RE: DA2019/0439, MOD2021/0016 and DA2021/0153
19 GUMNUT ROAD YAMBA

We have just been reviewing the Plans for the above DAs and modifications.

1. Photo taken 24 November 2020 of deck at 19 Gumnut Road Yamba sitting on non-complying foundations (the retaining wall) and non-complying deck is out over the revetment wall – Council neglected to locate revetment wall in accordance with Councils DCP Schedule C2 page 47, points 4 and 5.

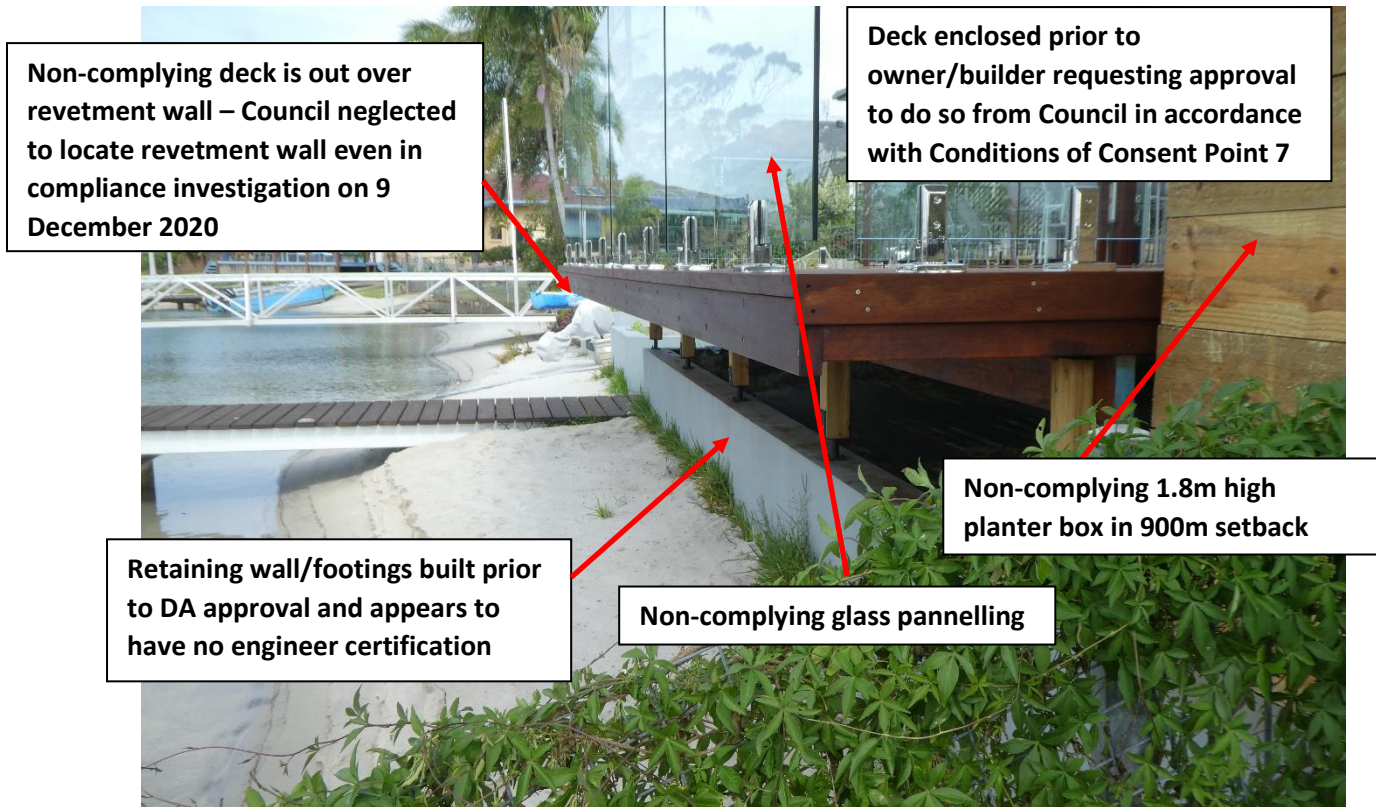
2. Photo of deck at 19 Gumnut Road Yamba sitting on footings (the retaining wall) taken 24 November 2020 – non complying downpipe, deck, footings, and overflow pipe

10. Photo taken 1 December 2020 19 Gumnut Road – downpipe and tank overflow still in place, non-complying glass panelling installed to deck. Non-complying roof larger than in Consent Plans and cantilevered to east, and Structural Plans show roof as a hip roof not flat

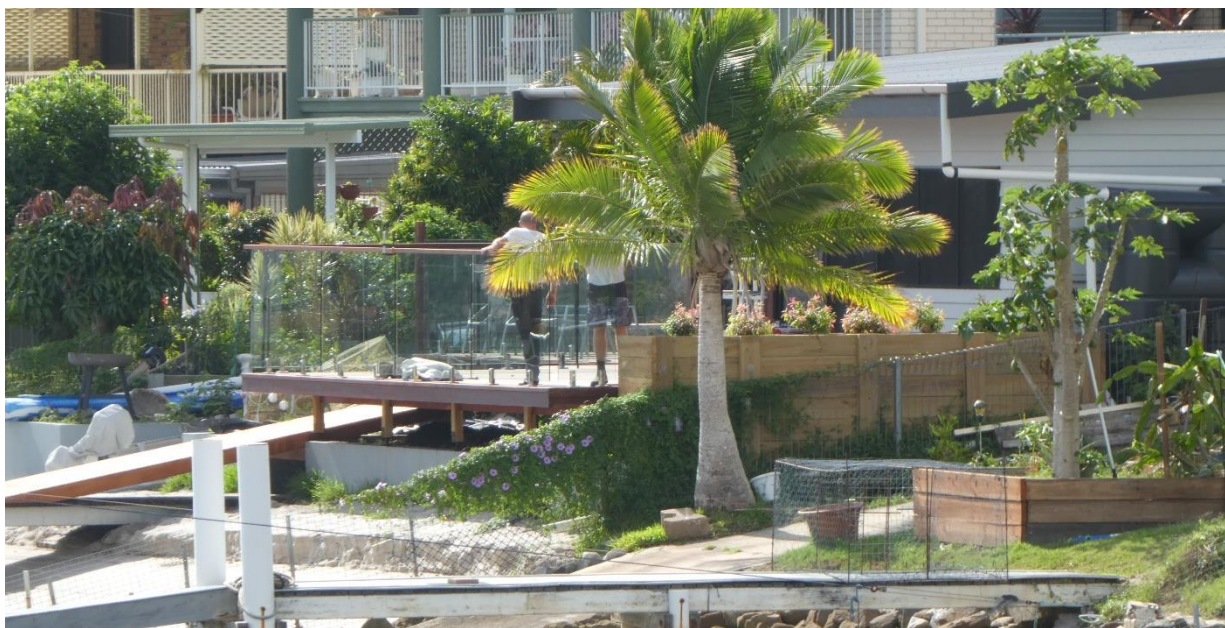
Larger extended non-complying roof cantilevered east towards pool

Downpipe along non-complying planter box and tank overflow on beach north of revetment wall

15. Photo taken 30 September 2018 of 19 Gumnut Road – outer extents of jetty demolished and removed back to first tall piers from the beachfront and pontoon being constructed on beachfront of 19 Gumnut Road. No retaining wall/footings constructed.

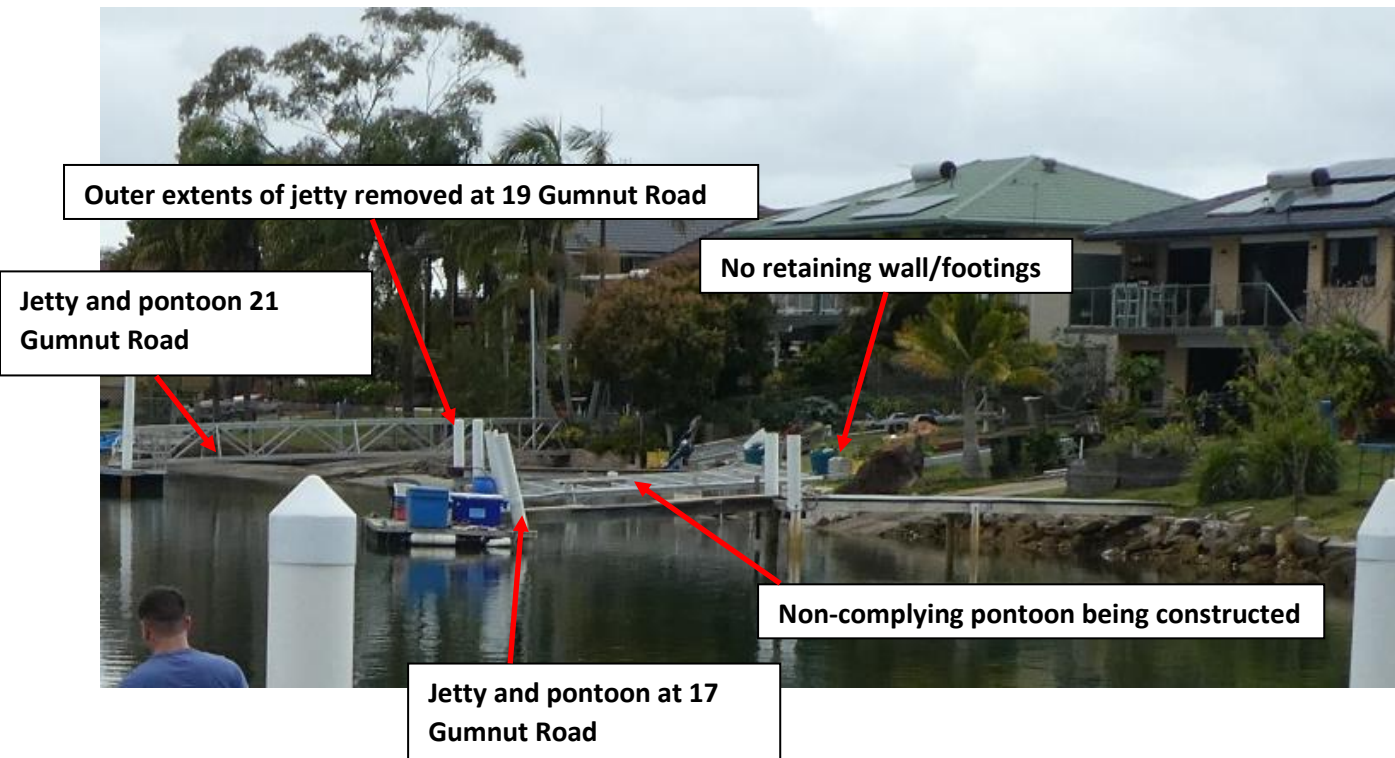
16. Photo taken 23 September 2019 showing retaining wall/footings already built prior to DA approval on 25 November 2019

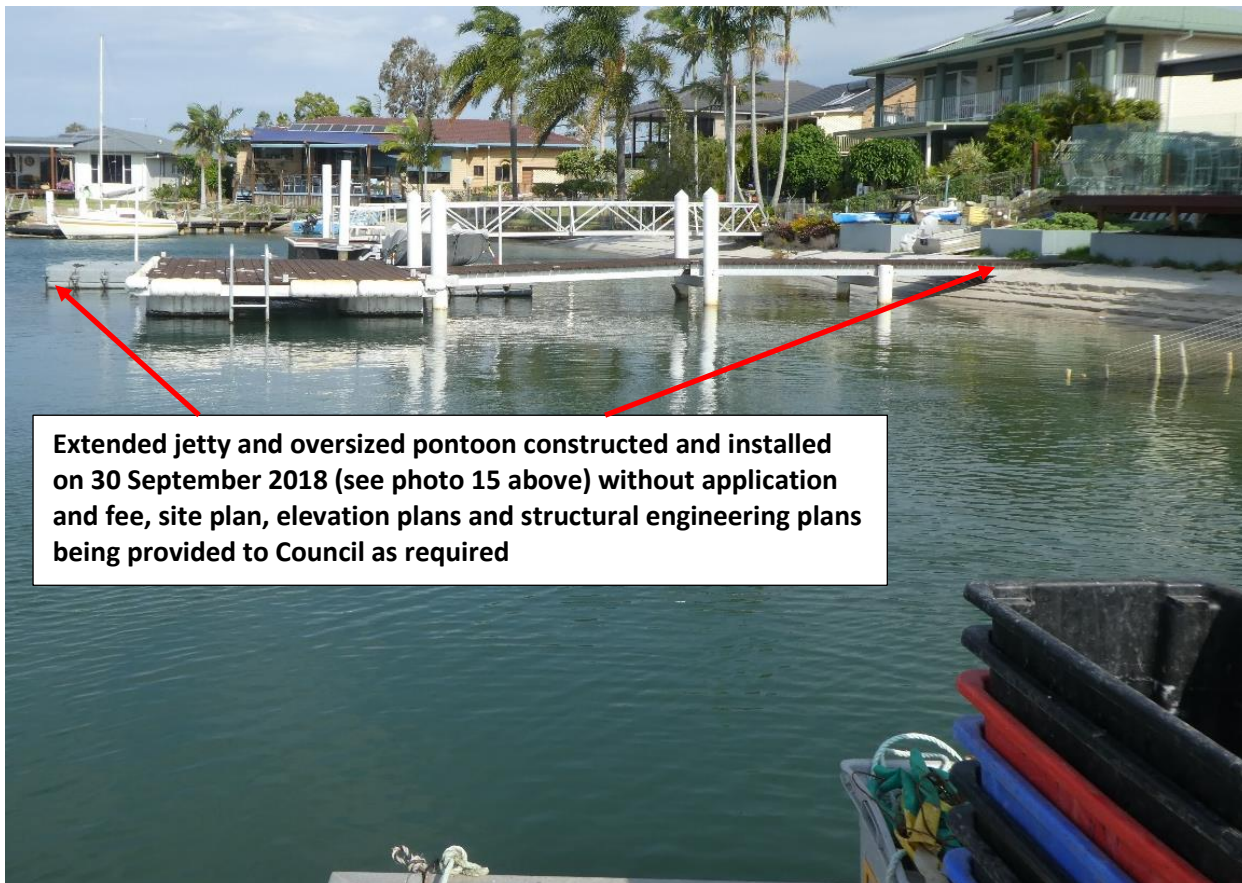
17. Photo taken 24 November 2020 at 19 Gumnut Road showing new extended jetty and oversized pontoon with boat storage attached to the eastern side of the pontoon (impeding access to pontoon at 21 Gumnut Road) – much larger and further out than previous jetty (photo taken from the outer edge of pontoon at 17 Gumnut Road).

Extended jetty and oversized pontoon constructed and installed on 30 September 2018 (see photo 15 above) without application and fee, site plan, elevation plans and structural engineering plans being provided to Council as required

22 a). Photo taken 29 October 2019 – backyard of 19 Gumnut Road Yamba – excavator filling behind already constructed retaining wall prior to DA2019/0439 approval

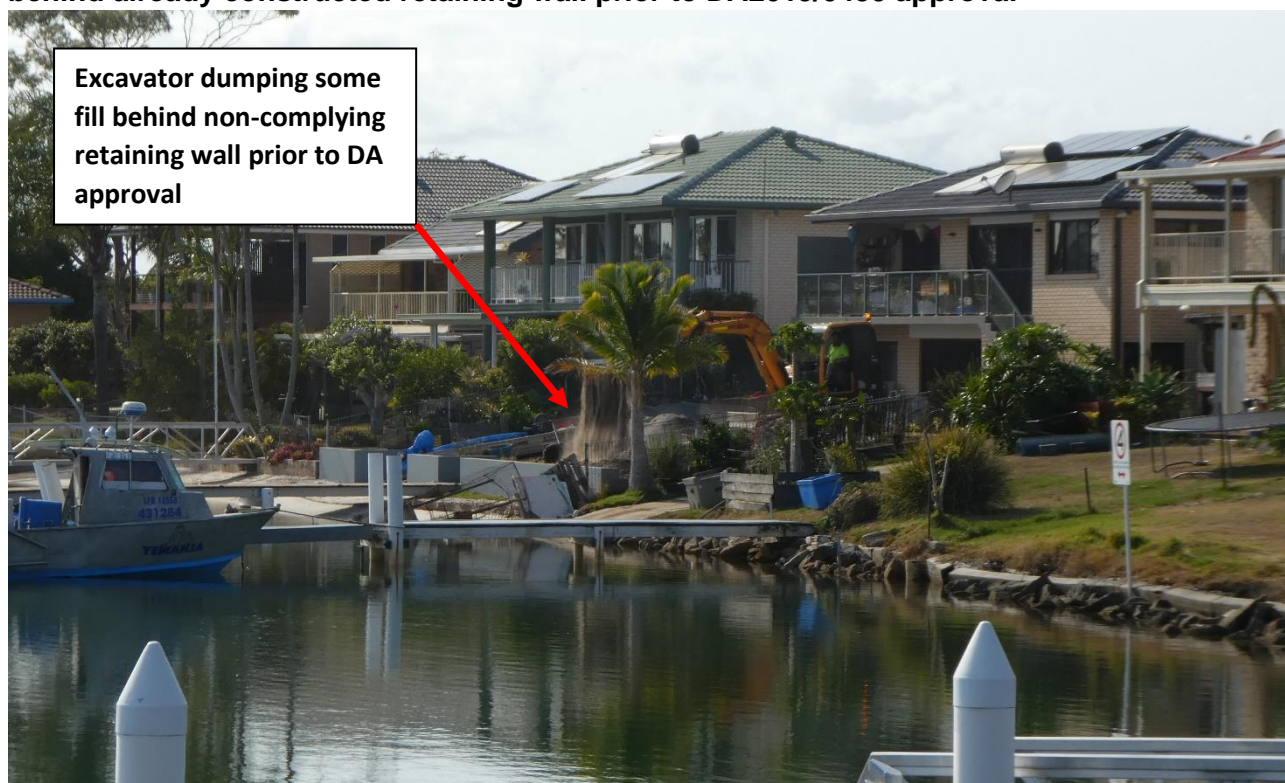
23. Photo taken 19 January 2018 – previous pontoon and jetty at 19 Gumnut Road Yamba – very different structure to new pontoon and jetty installed 30 September 2018.

1. Photo taken 24 November 2020 of deck at 19 Gumnut Road Yamba sitting on non-complying footings (the retaining wall) and non-complying deck is out over the revetment wall – Council neglected to locate revetment wall in accordance with Councils DCP Schedule C2 page 47, points 4 and 5.

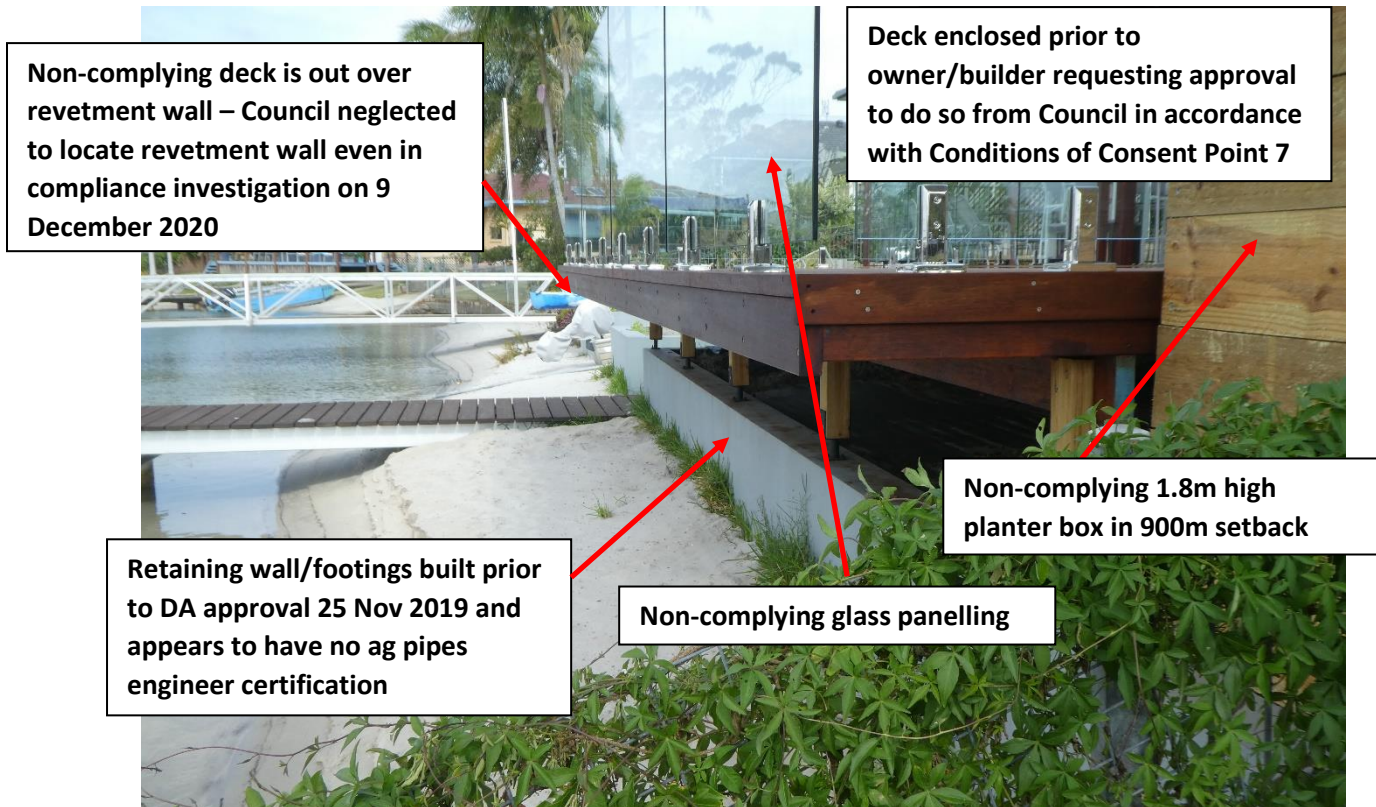
2. Photo of deck at 19 Gumnut Road Yamba sitting on footings (the retaining wall) taken 24 November 2020 – non complying downpipe, deck, footings, and overflow pipe

10. Photo taken 1 December 2020 19 Gumnut Road – downpipe and tank overflow still in place, non-complying glass panelling installed to deck. Non-complying roof larger than in Consent Plans and cantilevered to east, and Structural Plans show roof as a hip roof not flat

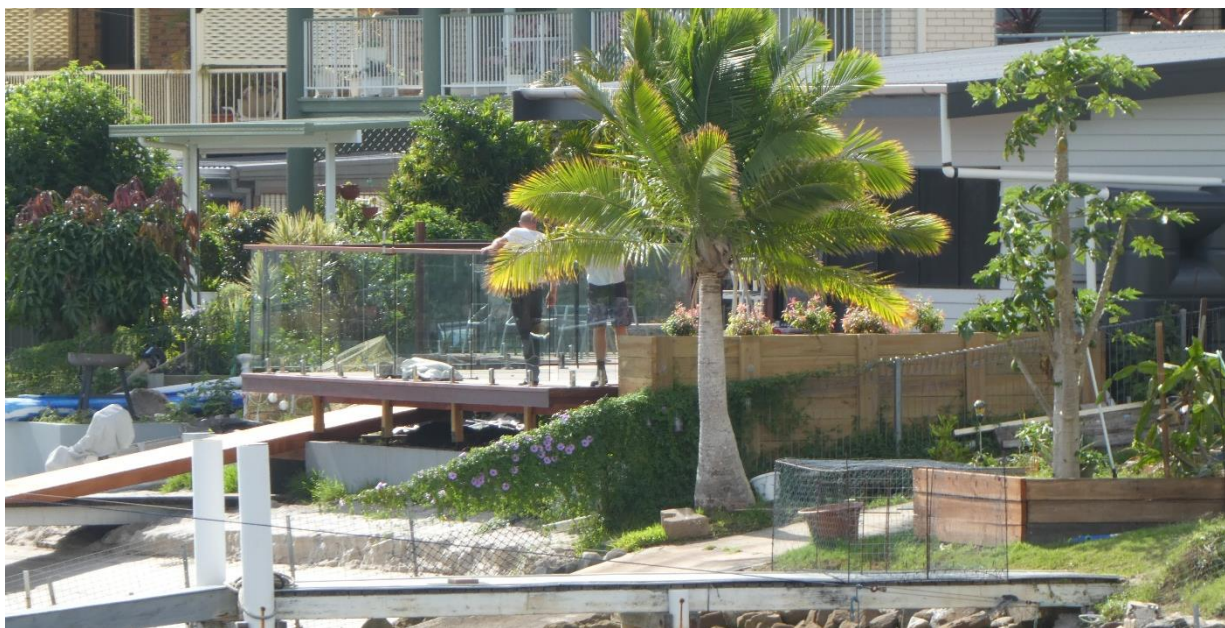
Larger extended non-complying roof cantilevered east towards pool

15. Photo taken 30 September 2018 of 19 Gumnut Road – outer extents of jetty demolished and removed back to first tall piers from the beachfront and pontoon being constructed on beachfront of 19 Gumnut Road. No retaining wall/footings constructed.

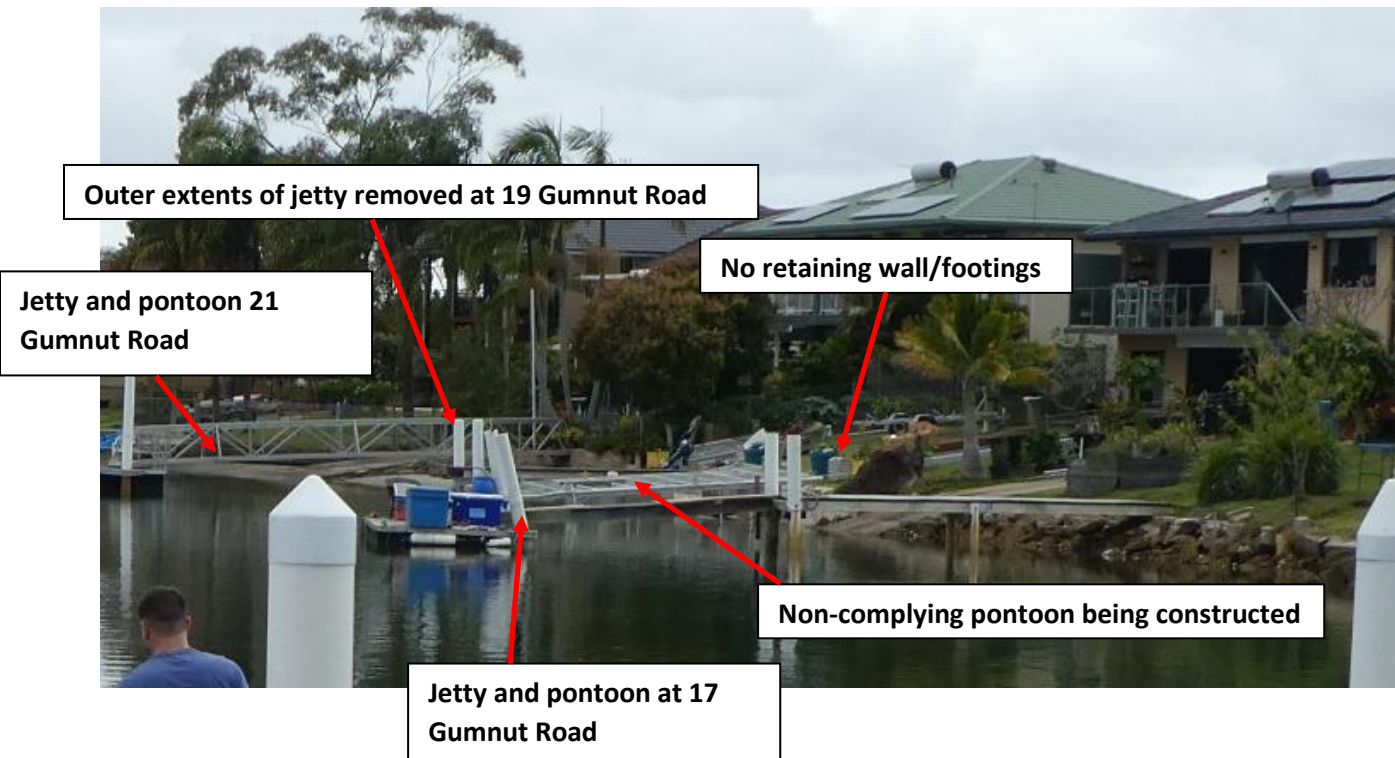
16. Photo taken 23 September 2019 showing retaining wall/footings already built prior to DA approval on 25 November 2019 (provided separately to Council)

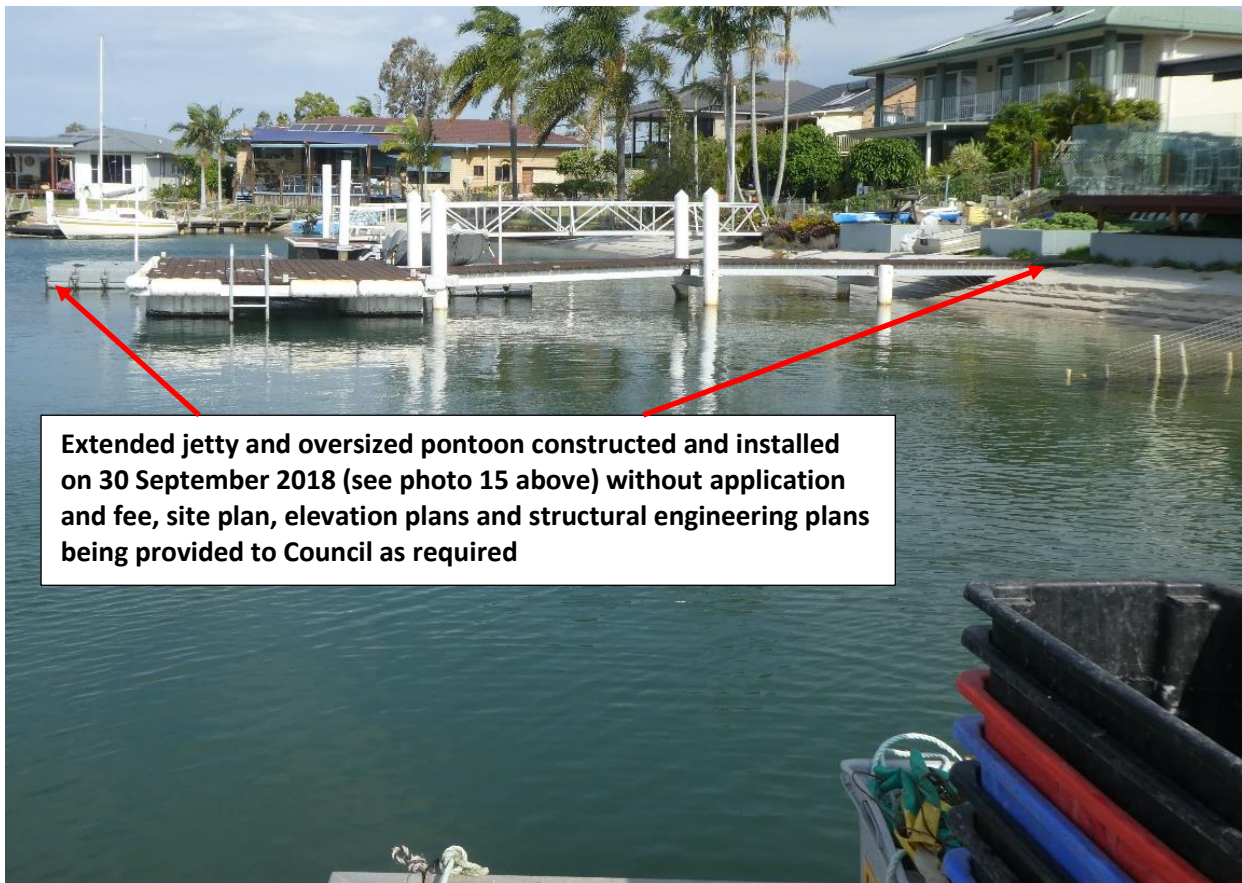
17. Photo taken 24 November 2020 at 19 Gumnut Road showing new extended jetty and oversized pontoon with boat storage attached to the eastern side of the pontoon (impeding access to pontoon at 21 Gumnut Road) – much larger and further out than previous jetty (photo taken from the outer edge of pontoon at 17 Gumnut Road).

Extended jetty and oversized pontoon constructed and installed on 30 September 2018 (see photo 15 above) without application and fee, site plan, elevation plans and structural engineering plans being provided to Council as required
